U.S. CONSUMER PRODUCT SAFETY COMMISSION
5 RESEARCH PLACE
ROCKVILLE, MD 20850

March 7, 2022

STAFF'S EXAMINATION OF
HEATER POWER CORD PLUGS

Examination of Heater Power Cord Plugs

Incident - Sample 0803_02

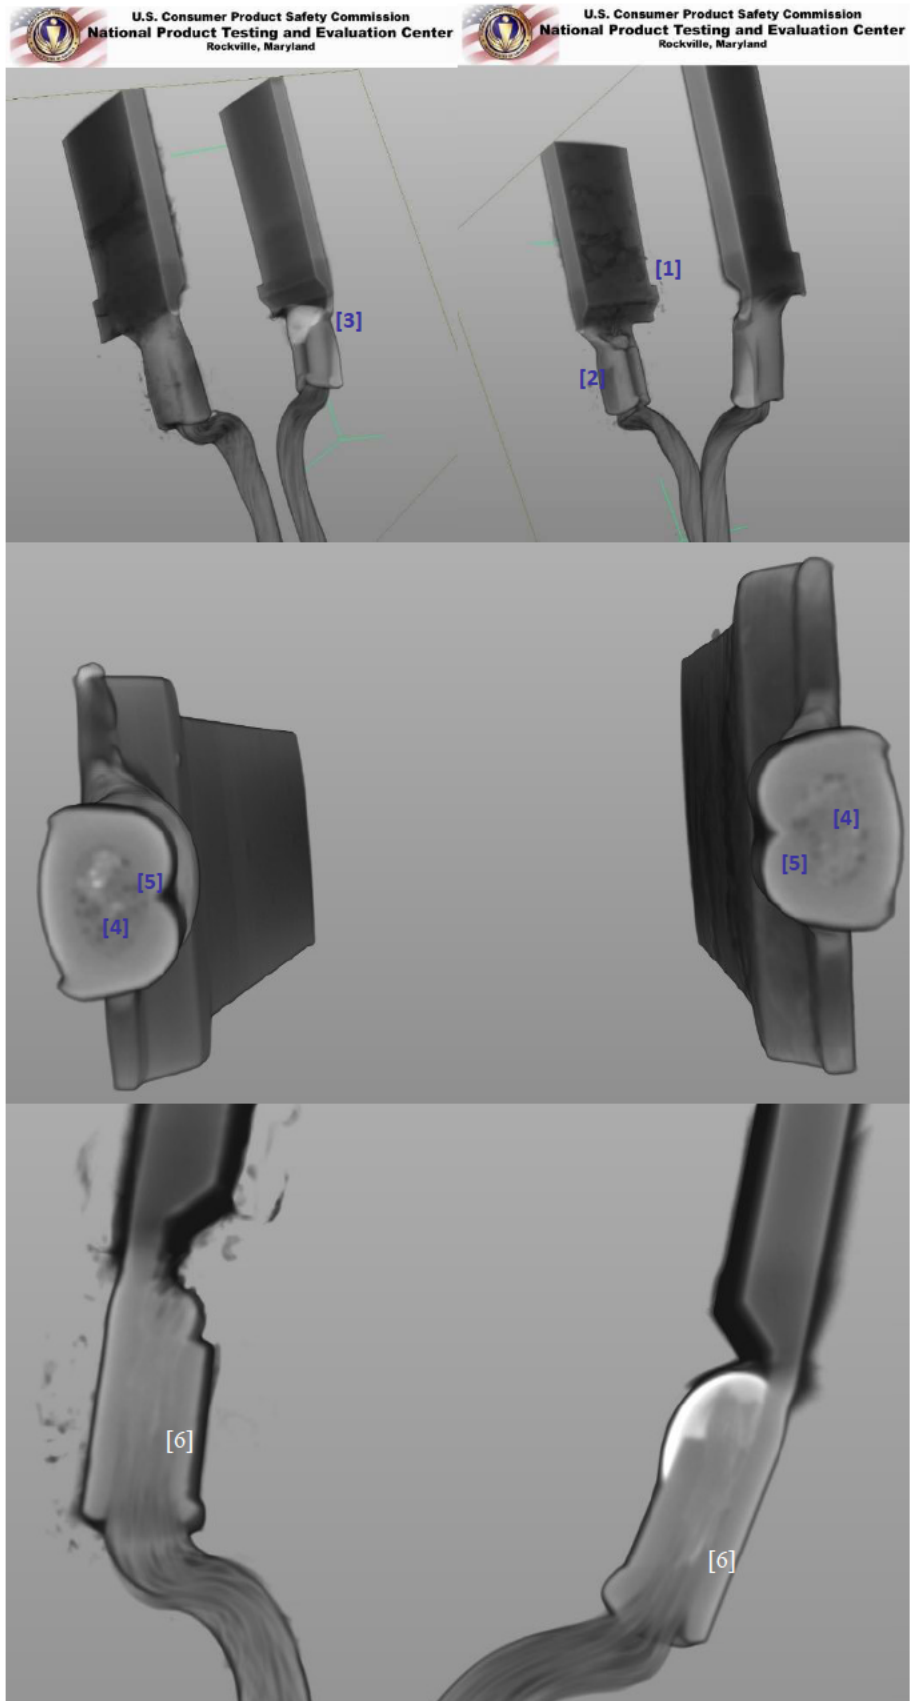
One of the two blades showed signs of overheating, which resulted in deformation/melting of the plug overmold.

[1] Thermal damage surrounding the crimp connection (not visible on x-rays).

[2] Insufficient solder to bond the wire strands to the terminal surface.

[3] Solder above the crimp barrel location to bond the wire strands to the terminal surface.

[4] Voids in the crimp.

[5] Crimp wing closed but not turned inwards to complete fully closed/pressure crimp barrel.

[6] Solder flow into main crimp area is an indication of voids in the crimp barrel before soldering.

Incident - Sample 0087

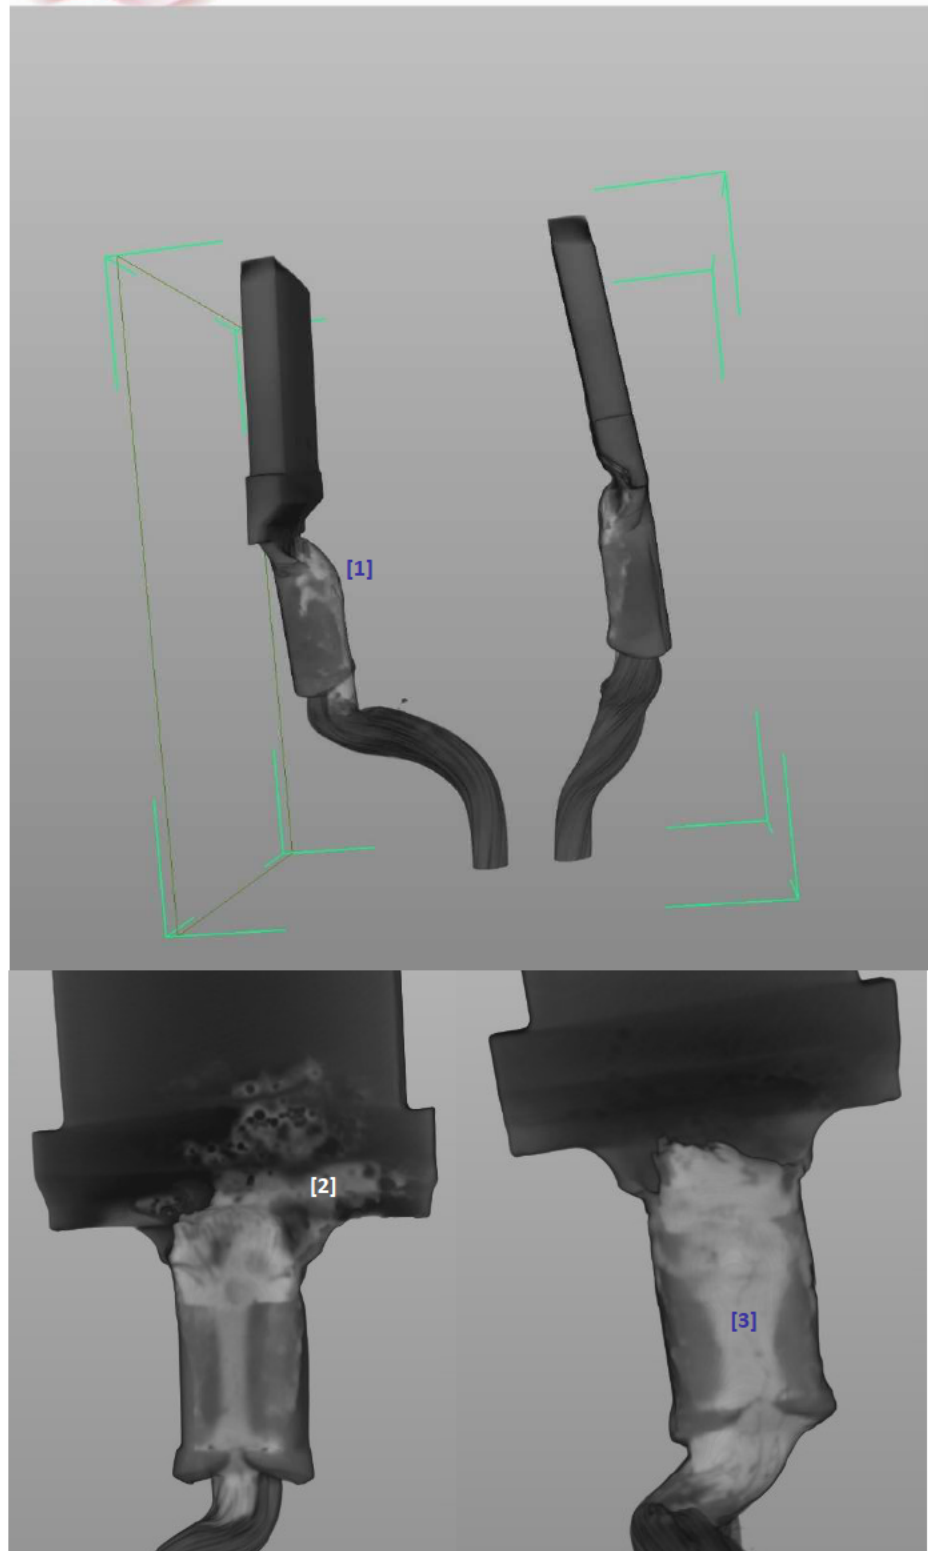
One of the two blades showed signs of overheating, which resulted in deformation/melting of the molded plug.

[1] Thermal damage surrounding the crimp connection (not visible on x-ray).

[2] Thermal damage visible on the surface.

[3] Surface solder mainly covering the wings of the crimp barrel.

Incident - Sample 0087

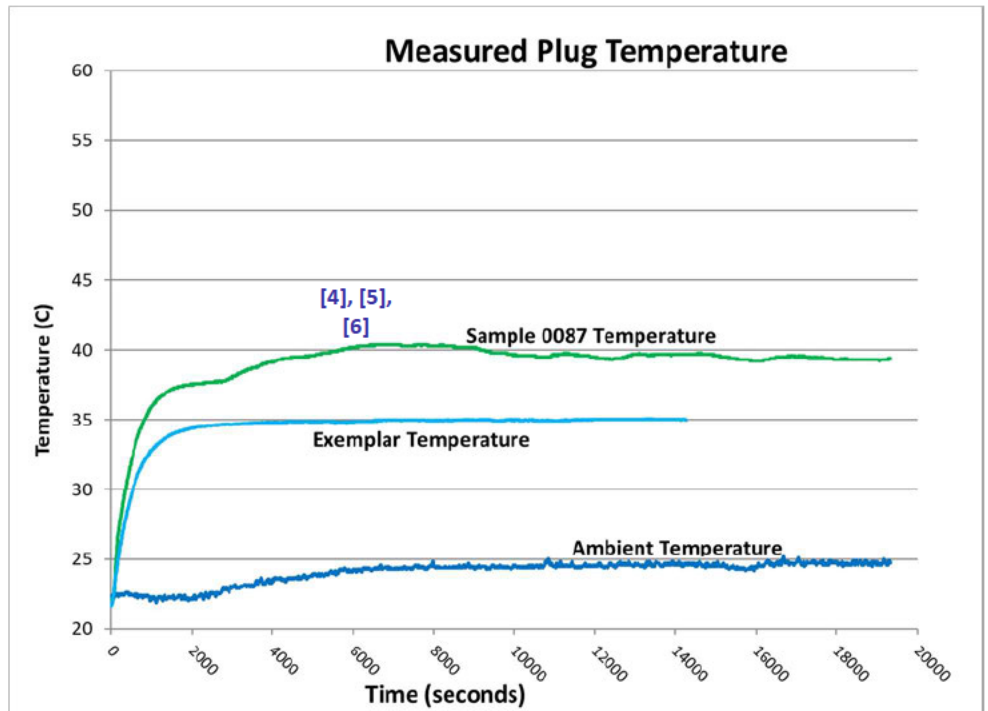
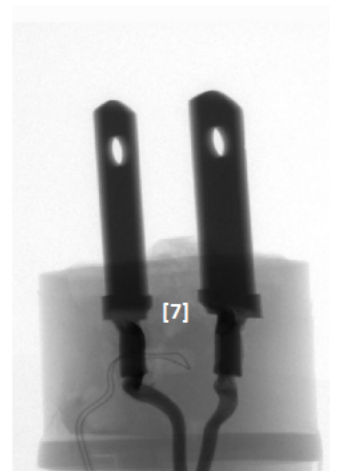
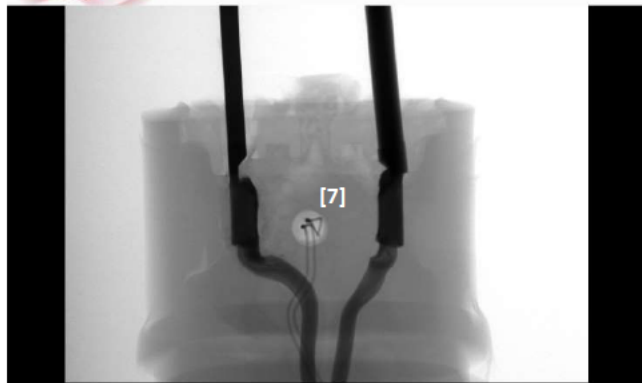
[4] The maximum temperature increase above ambient temperatures was 16.2°C @ about 1.8 hours (6460 seconds).

[5] The maximum temperature increase above exemplar sample temperatures was 5.5°C @ about 1.72 hours (6420 seconds).

[6] The maximum temperature for the incident sample was 40.4°C @ about 1.72 hours (6420 seconds).

[7] Thermocouple located between the crimp barrels within the molded plug.

Incident - Sample 0090

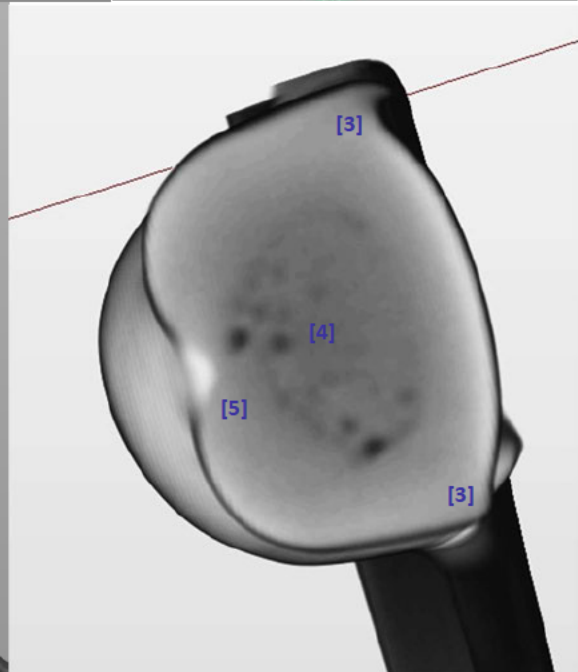
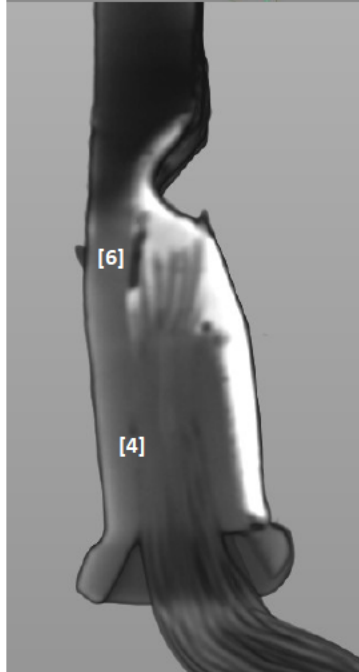
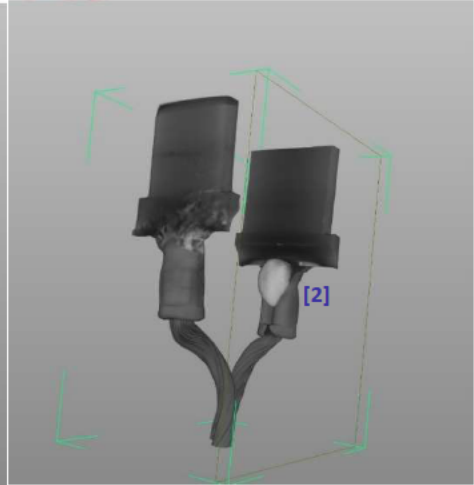
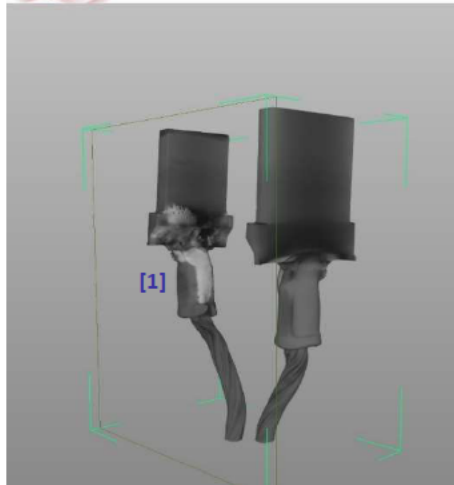
One of the two blades showed signs of overheating, which resulted in deformation/melting of the plug overmold (not visible on the x-rays).

[1] Thermal damage surrounding the crimp connection (not visible on the x-ray).

[2] Solder bead at top of wire strands.

[3] Uneven burrs/extrusions (sign of asymmetric crimp pressure).

[4] Voids in the crimp barrel.

[5] Uneven crimp barrel closure.

[6] Voids in the solder bond to terminal surface.

Incident - Sample 0090

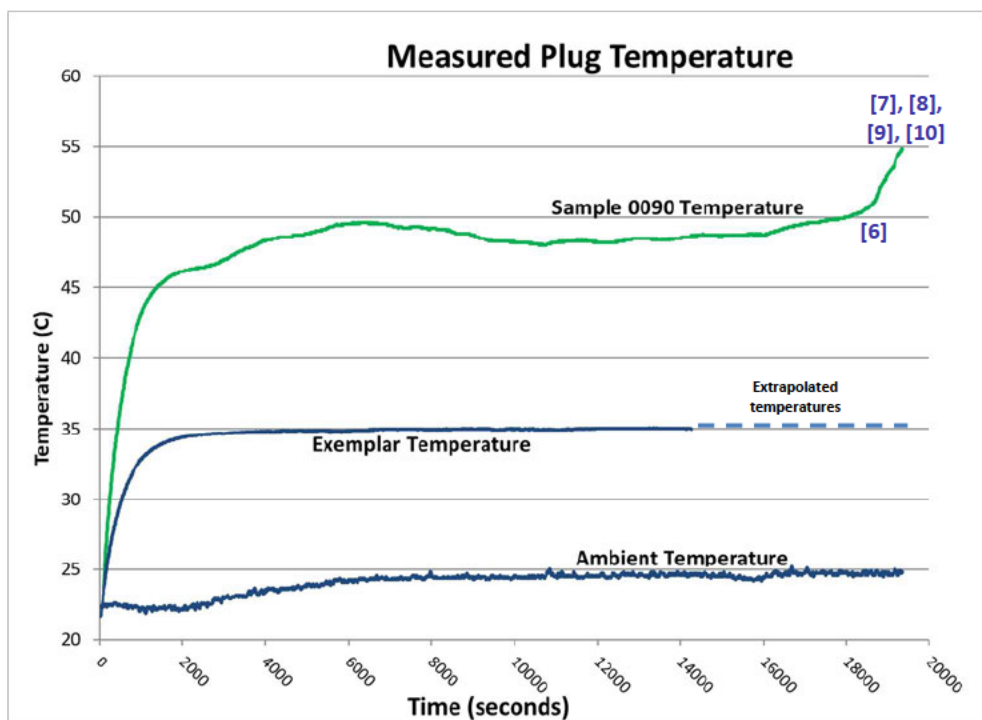
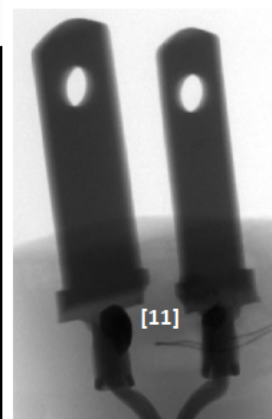
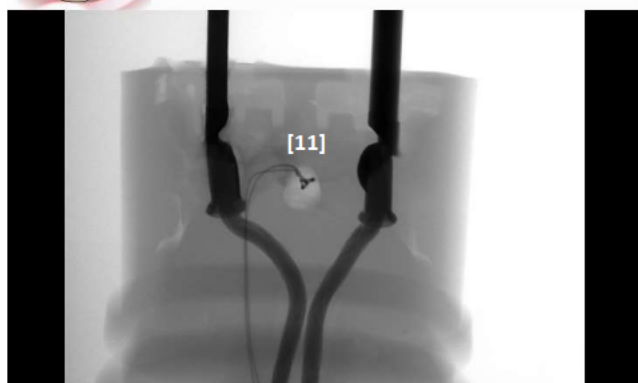
[6] Steep rise in temperature after about 5 hours.

[7] The maximum temperature rise was 30.1°C @ about 5.4 hours (19340 seconds).

[8] The maximum temperature difference between incident and exemplar temperatures was 19.8°C @ about 5.4 hours (19340 seconds).

[9] The maximum temperature for the incident sample was 54.8°C @ about 5.4 hours (19340 seconds).

[10] The temperature leveled or declined after 19340 seconds.

Incident - Sample
0803_01

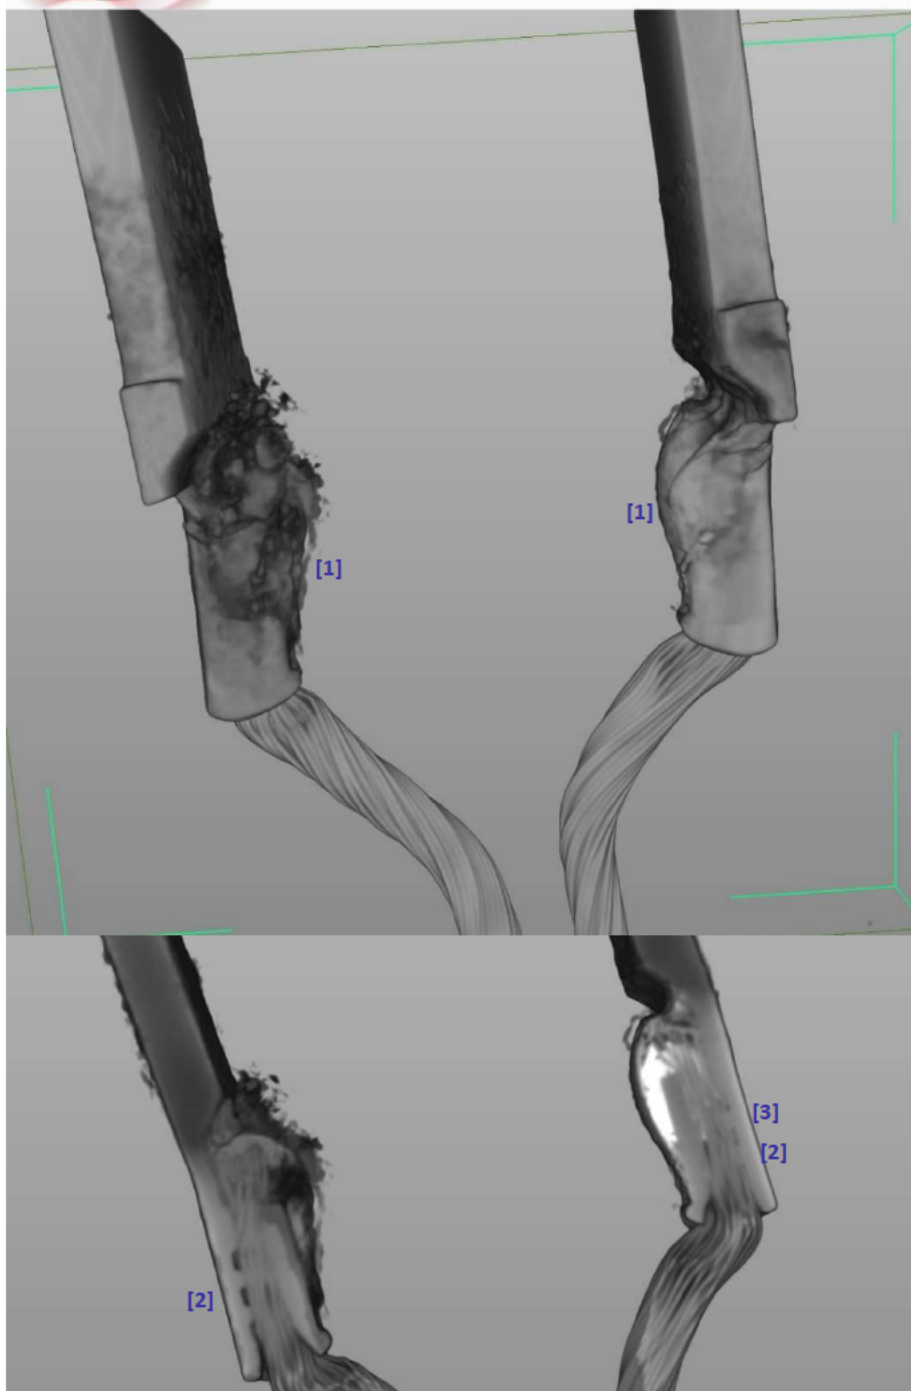
One of the blades showed signs of overheating, which resulted in deformation/melting plug overmold.

[1] Thermal damage surrounding the crimp connection. Solder had melted and solidified.

[2] Voids in the crimp barrel.

[3] Solder flow into main crimp area is an indication of insufficient crimp barrel pressure.

Incident - Sample 0803_01

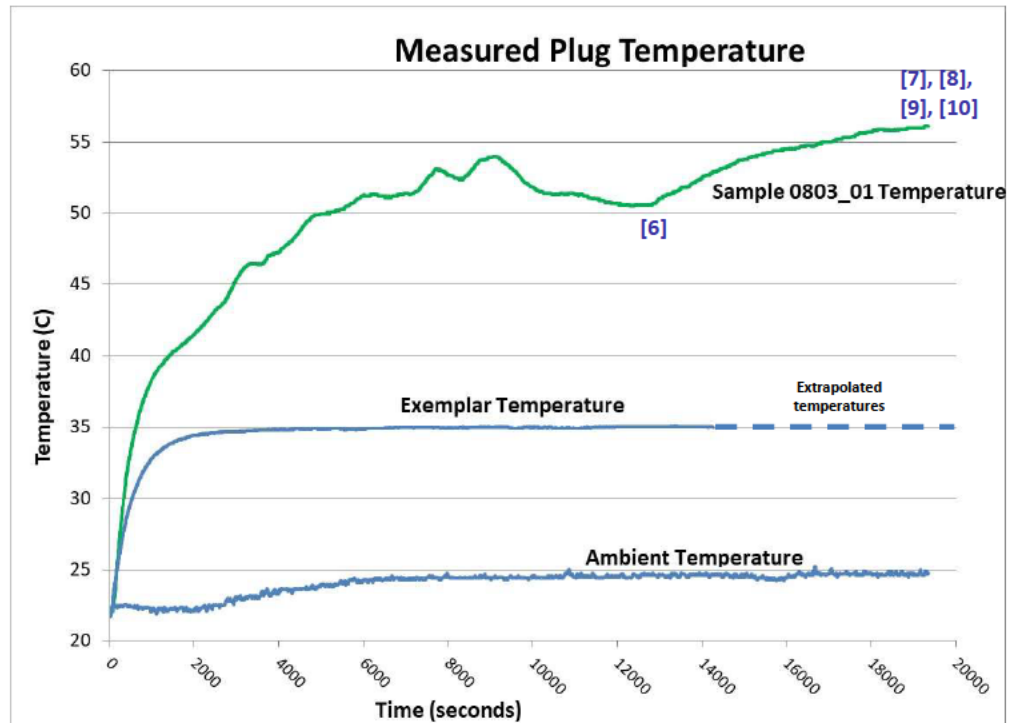
[6] Steep rise in temperature after 3.5 hours.

[7] The maximum rise above ambient temperatures was 31.5° C @ about 5.4 hours (19260 seconds).

[8] The maximum rise above exemplar temperatures was 19.8° C @ about 5.4 hours (19260 seconds).

[9] The maximum temperature for the incident sample was 54.8° C @ about 5.4 hours (19260 seconds).

[10] The temperature leveled or declined after 19260 seconds.

Exemplar - Sample 0447

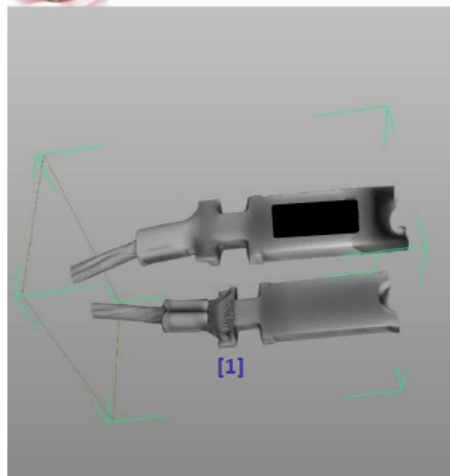
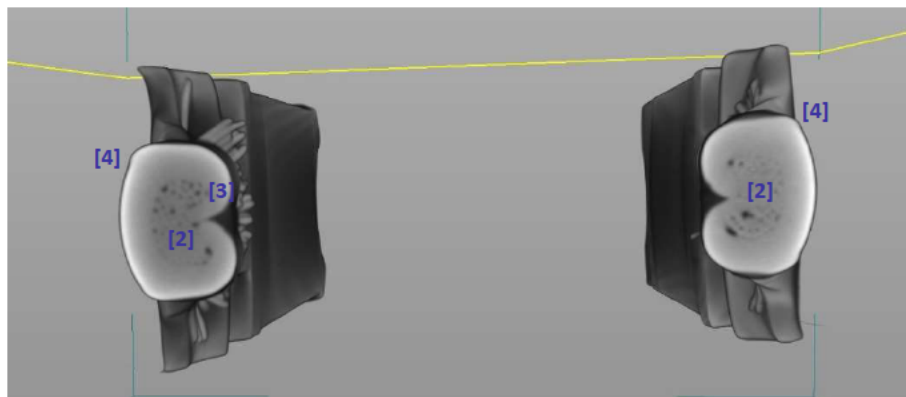
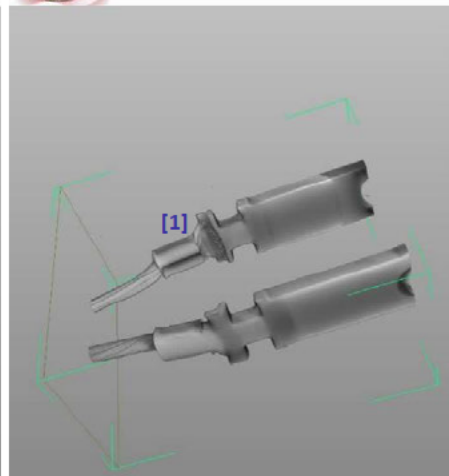
[1] For this sample, a bar weld is used across the wire strands.

[2] Voids in the crimp barrel.

[3] Uneven crimp barrel closure.

[4] Lack of burrs/extrusions is an indication of insufficient crimp pressure to close crimp barrel.

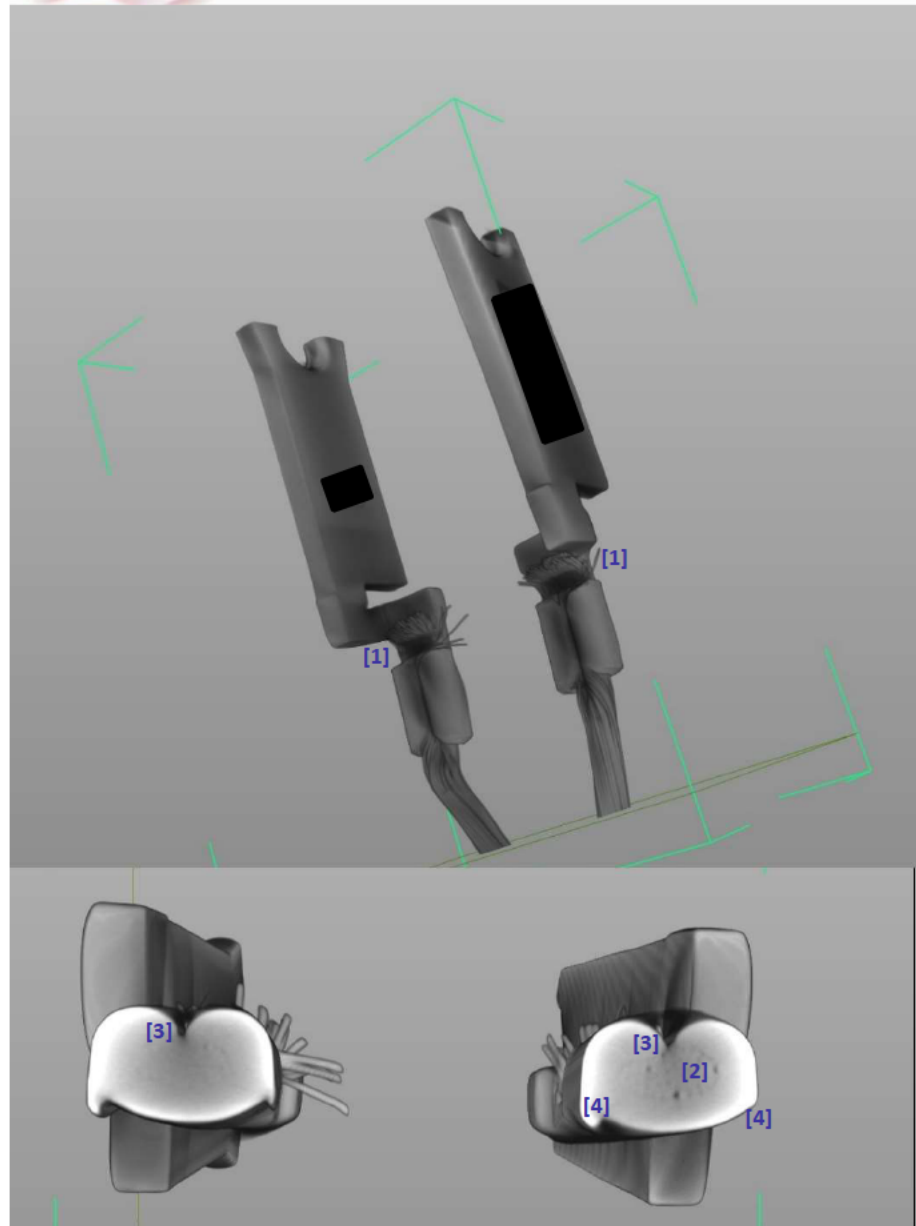
[1] For this sample, bar weld is used across the wire strands.

[2] Voids in the crimp barrel. Not all wire strands are deformed.

[3] Open crimp barrel. Crimp wings partially open and not touching.

[4] Asymmetric crimp. Uneven burrs/extrusions.
